# Comments on #SDP-26-0003 - Planning & Zoning: Site Development Plan

Application Number: #SDP-26-0003  
Application Type: Site Development Plan  
Date: May 29, 2026  
Address: 748 S MAIN ST, ROLESVILLE  
Parcel: 1758465891

The Rolesville Planning Department has reviewed your application for a Site Development Plan Application and has responded with a set of comments that require your attention. These comments must be addressed in full before an approval will be issued.

SHEET TITLE:  
 GRADING & DRAINAGE PLAN

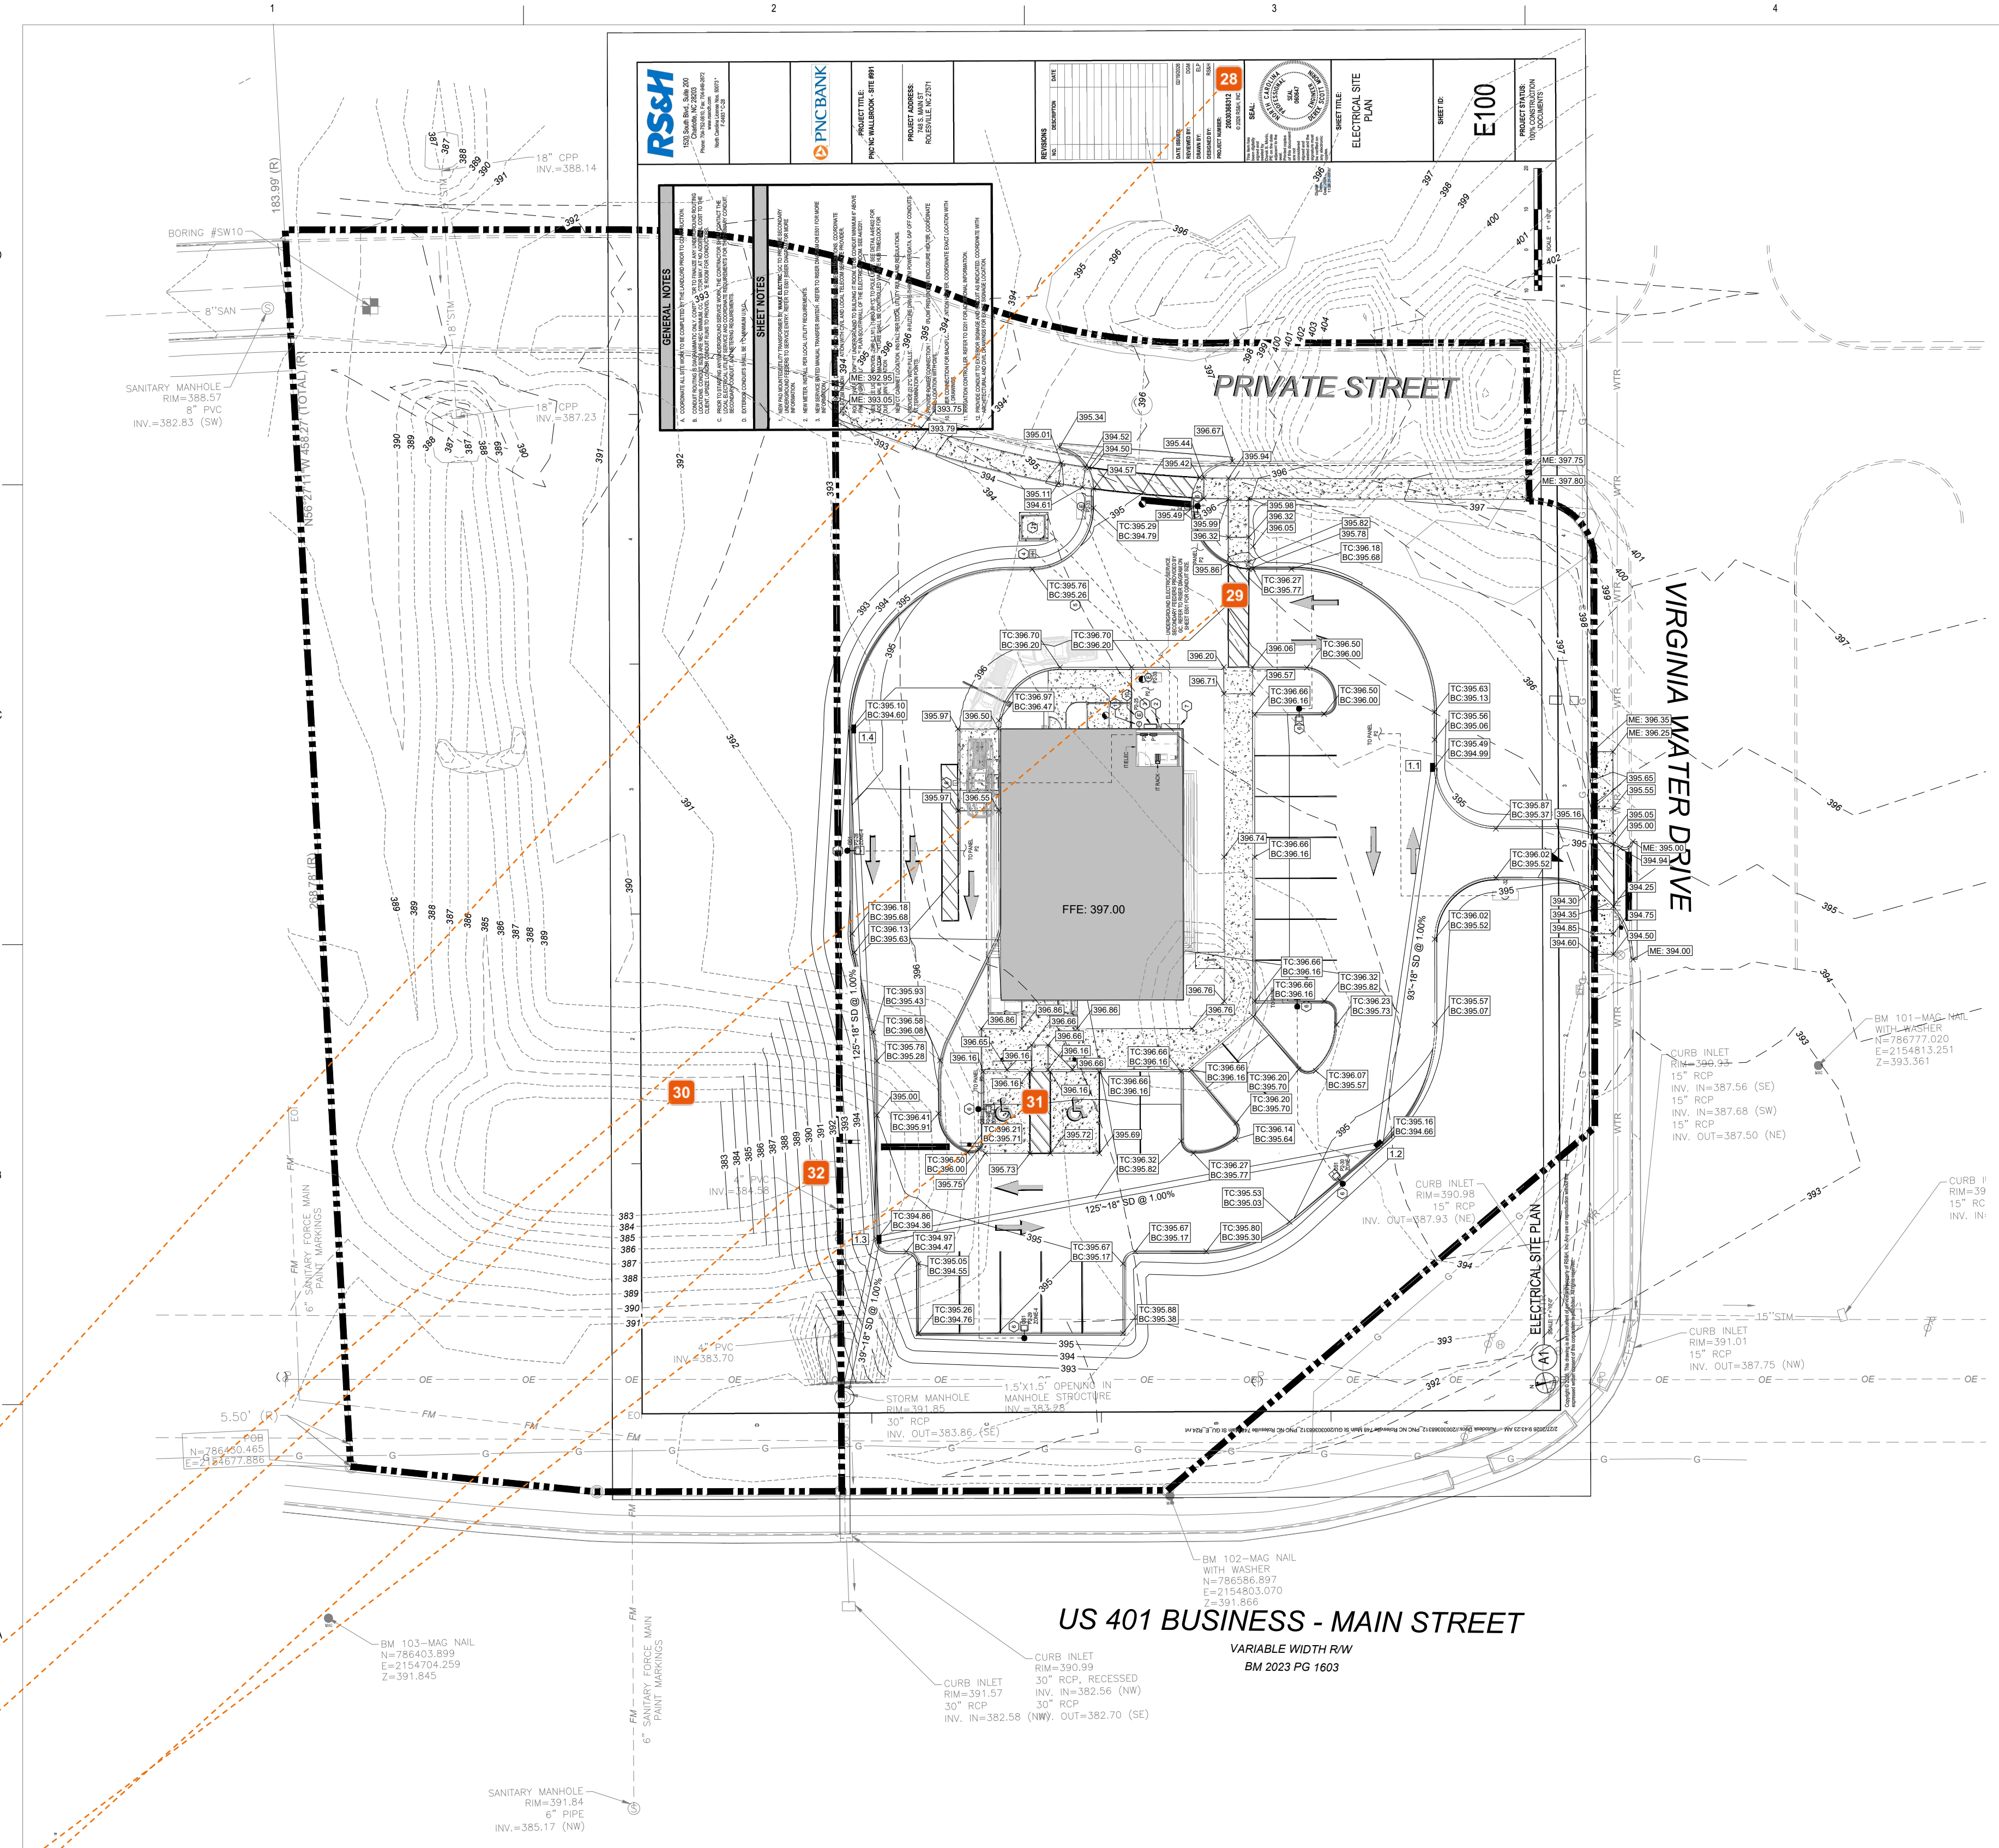
- 28** Jacqueline Thompson  
Clean up this sheet overlay.
- 29** Jacqueline Thompson  
Please confirm if there are pedestrian ramps to be located here. If so, please show truncated domes. Also confirm all grades meet ADA compliance.
- 30** Jacqueline Thompson  
Please clarify what the plan for this basin is. It appears a temporary construction easement may be needed. If the basin is filled in partially, will it remain large enough to manage the water coming into it from the northwest? If the skimmer is removed, how will water exit the basin? Please clarify the management of the drainage with this proposed construction.
- 31** Jacqueline Thompson  
Please review your grades to ensure ADA compliance of maximum 2% grades in all directions for accessible spaces.
- 32** Jacqueline Thompson  
Please confirm if any demo is occurring. There is a skimmer and PVC pipe in this area.

**SHEET TITLE:**  
DIMENSIONED FLOOR PLAN

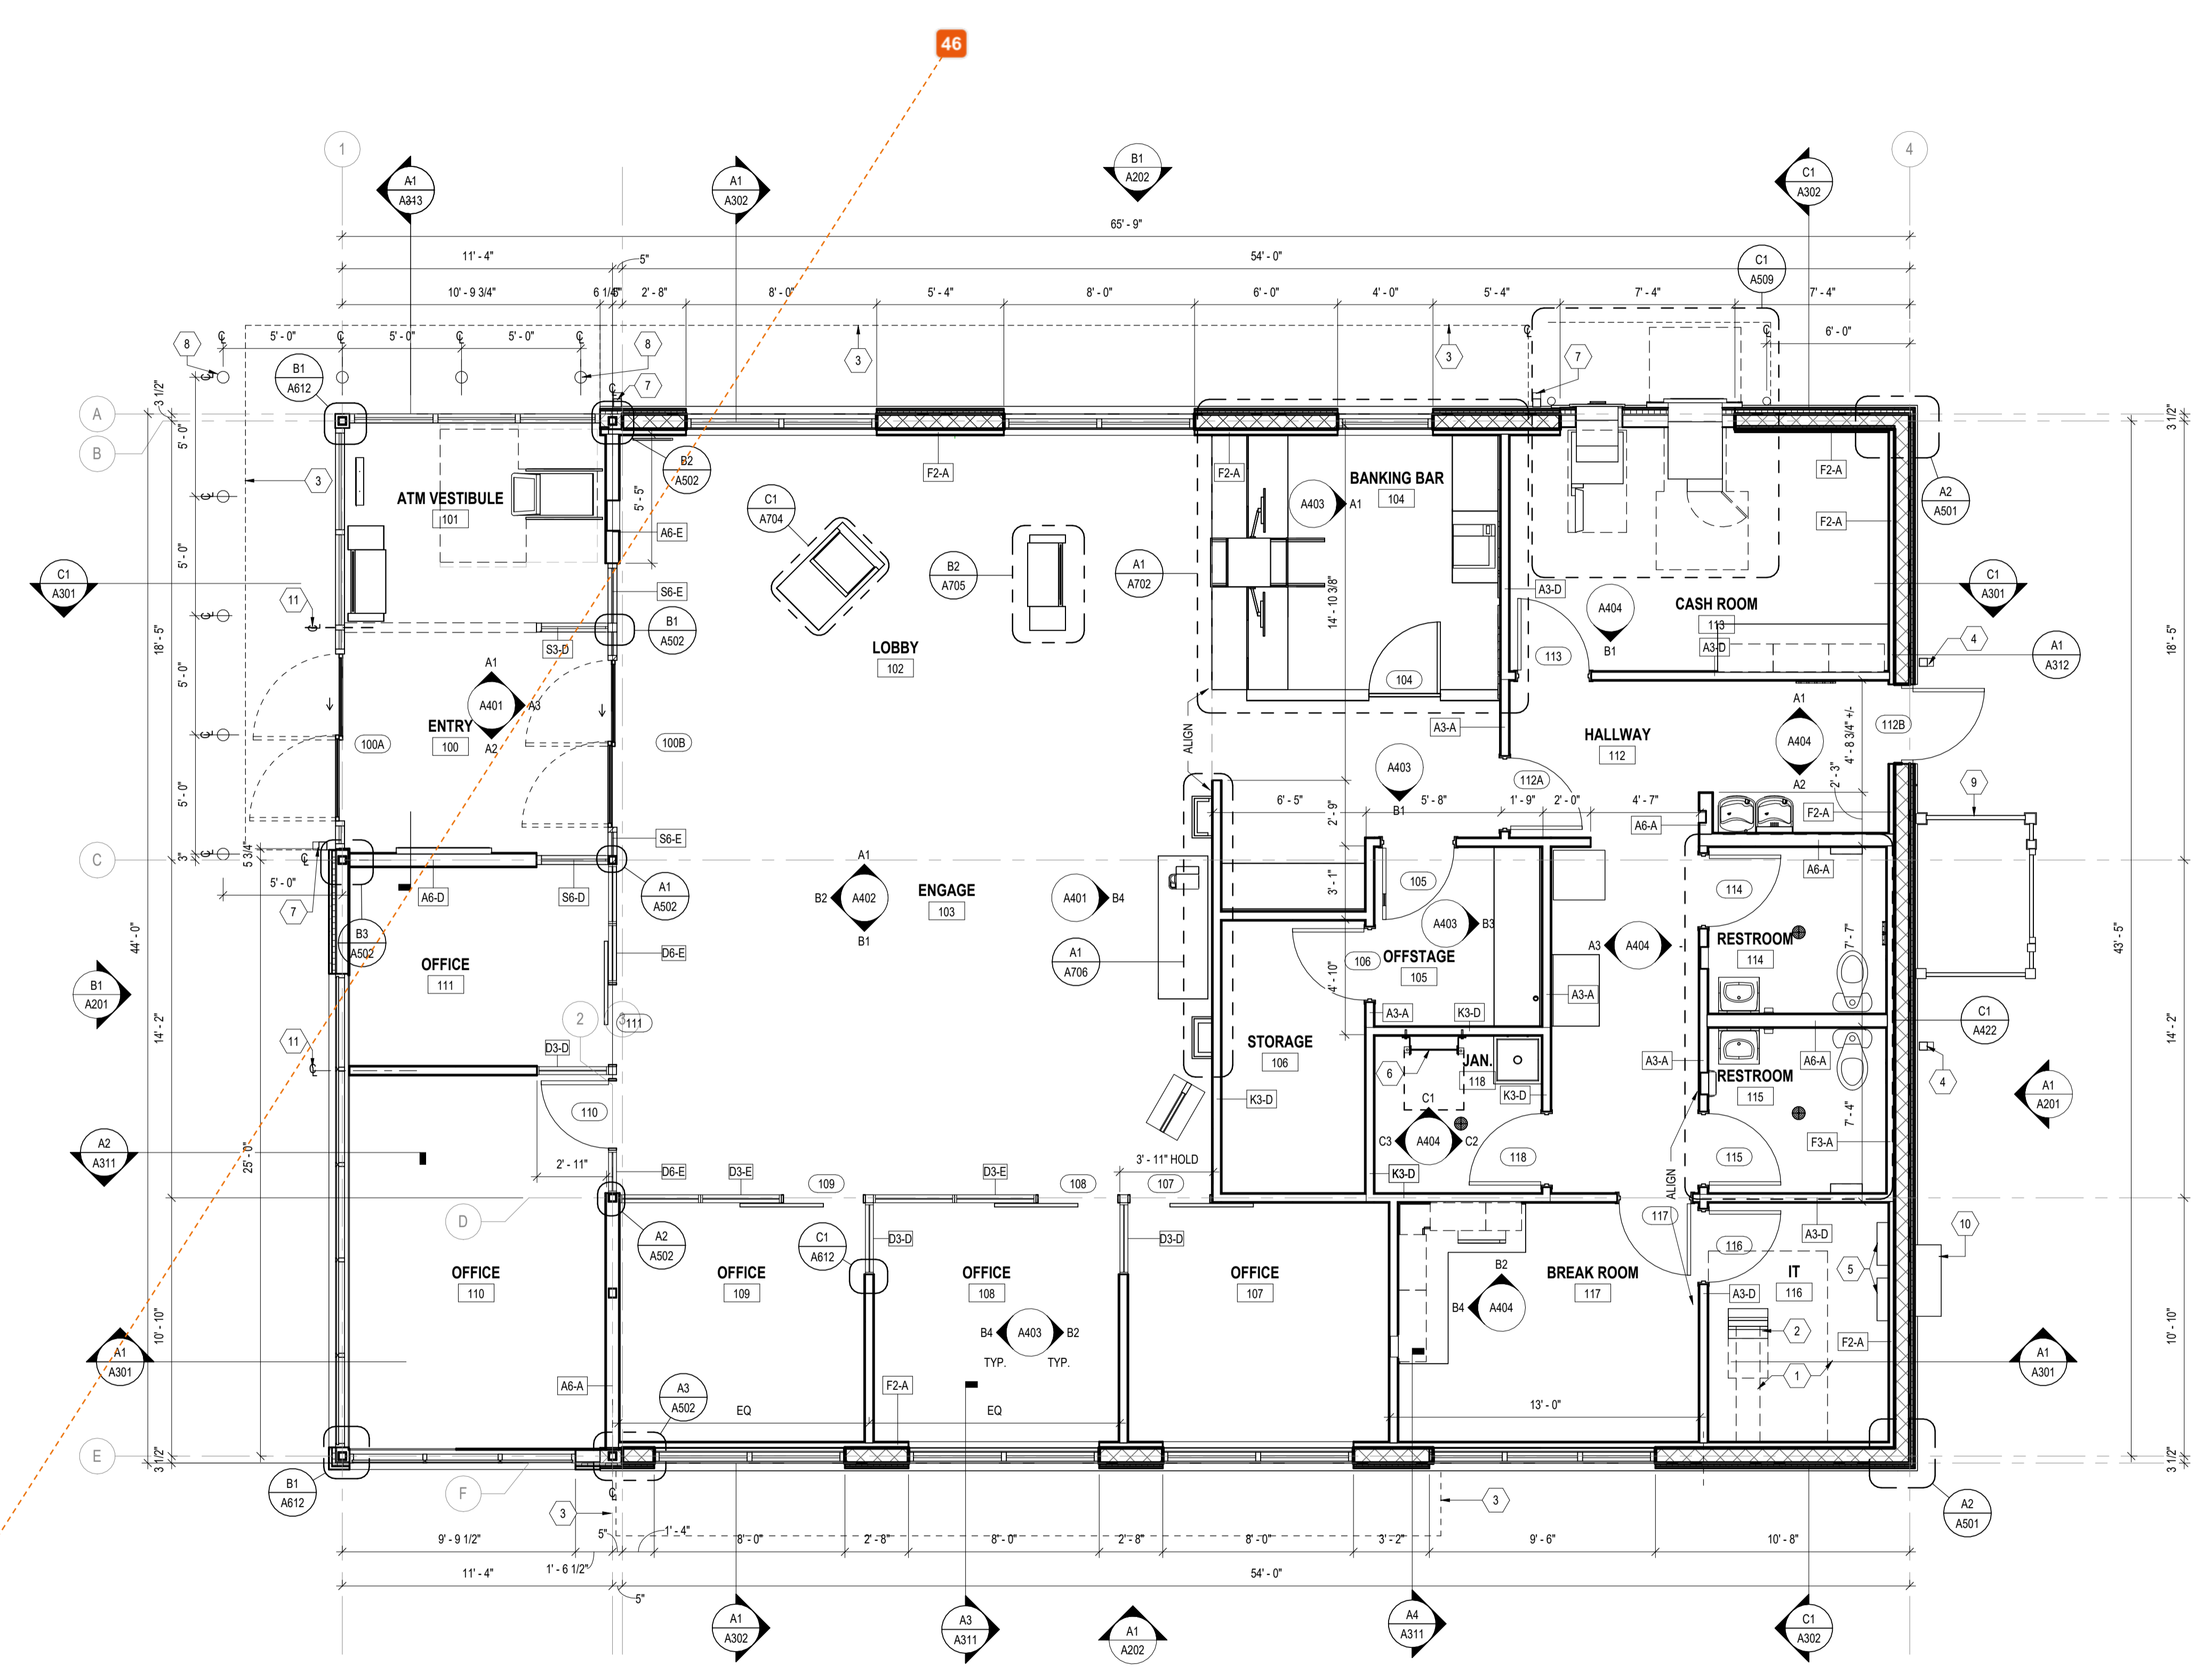
**FYI - interior plans are NOT being reviewed in this SDP.**

**SHEET TITLE:**  
BUILDING ELEVATIONS

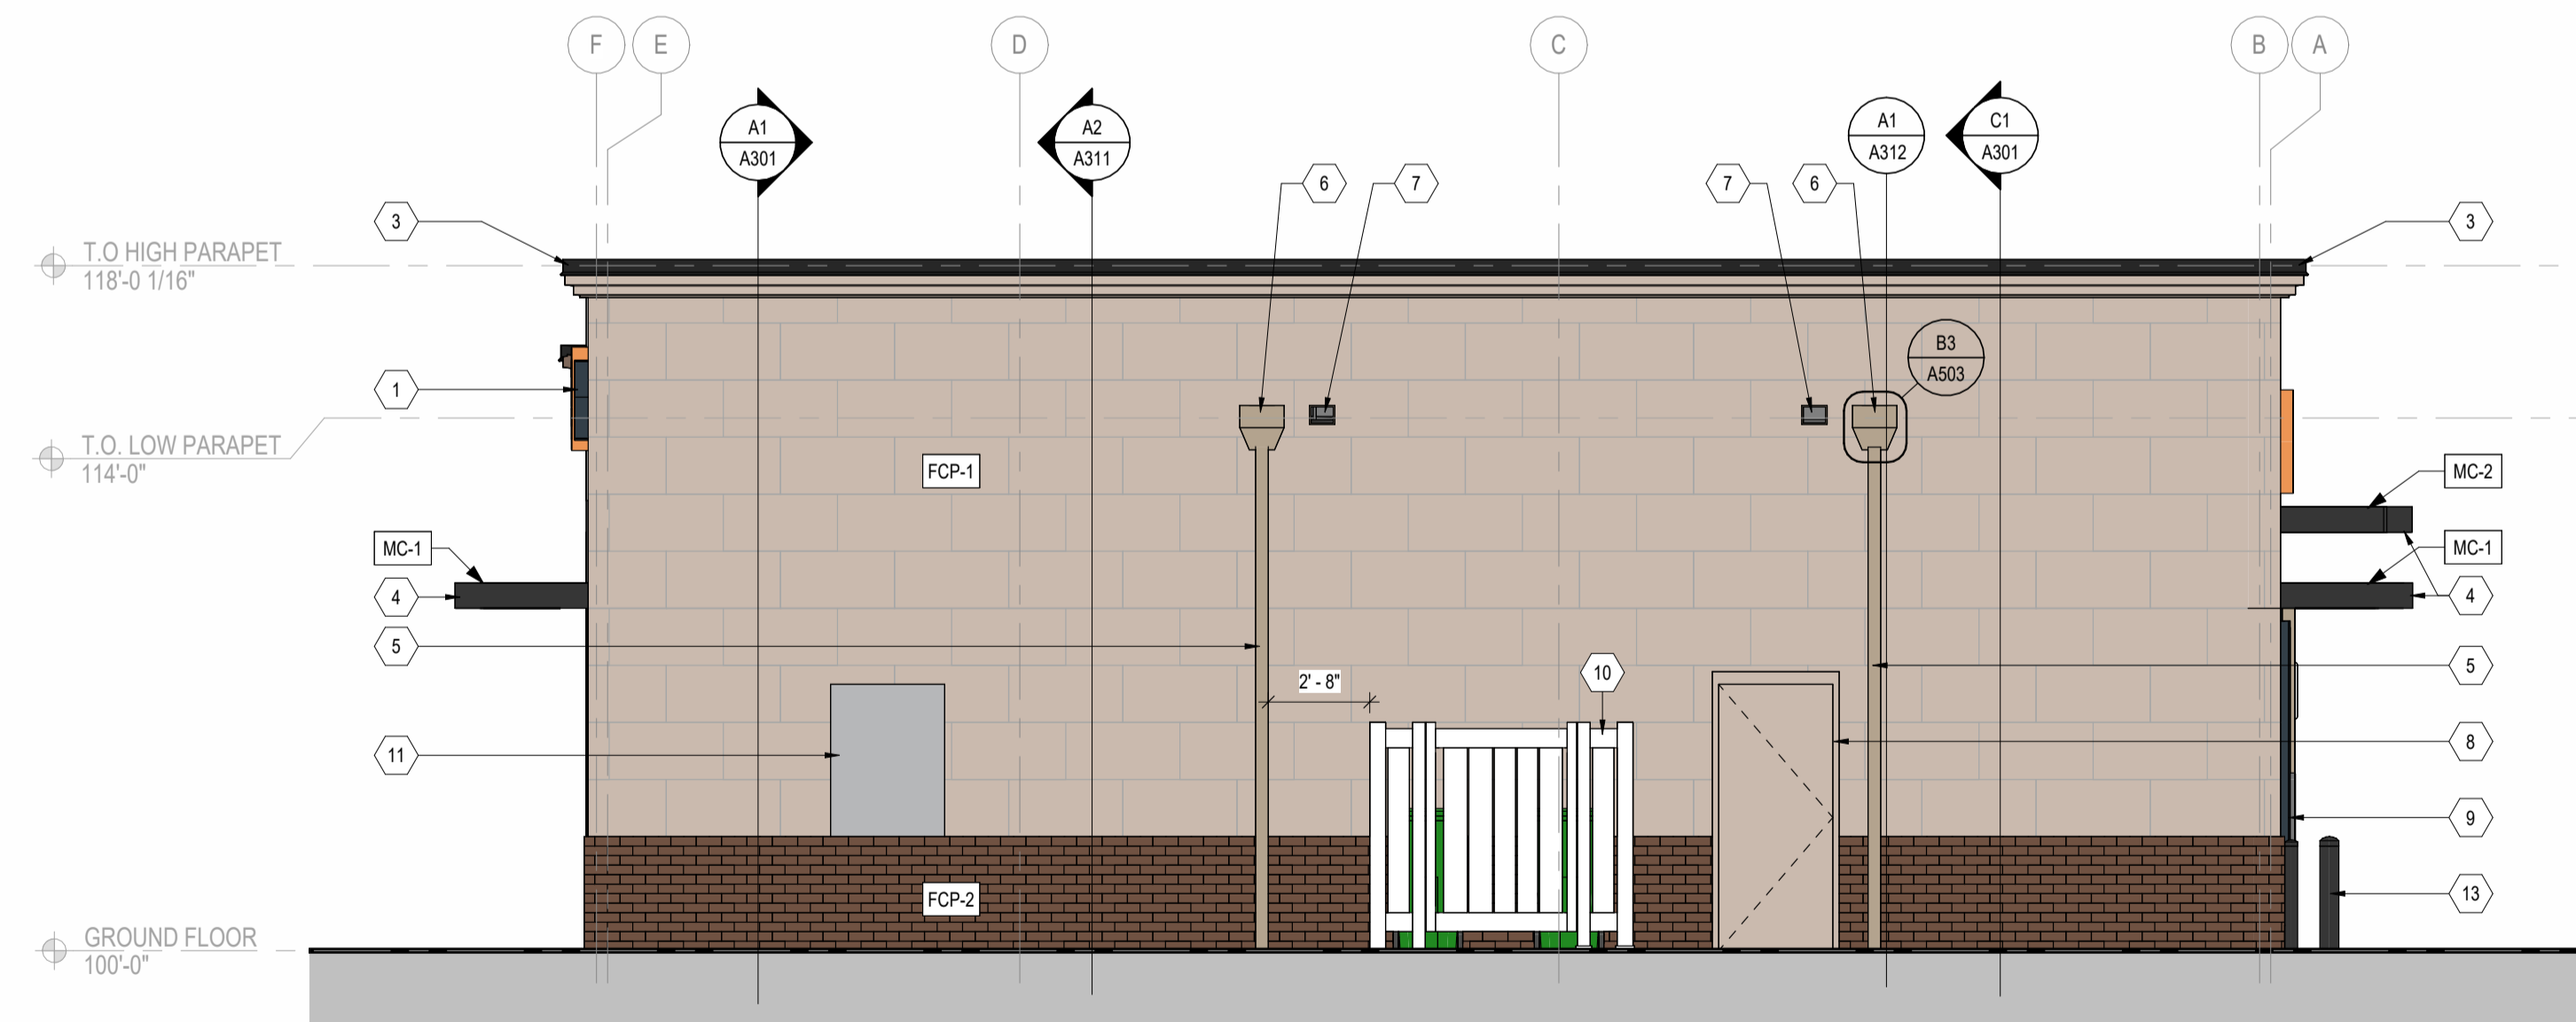
**48 Meredith Gruber**  
Verify compliance with LDO Section 6.8.2.D. Architectural Design Standards by adding notations and/or a table noting required and provided items. Design Standards include Facades, Transparency, Blank Wall Area, Materials, Colors, etc.

**49 Meredith Gruber**  
Add a graphic scale to facilitate review of the architectural elevations.
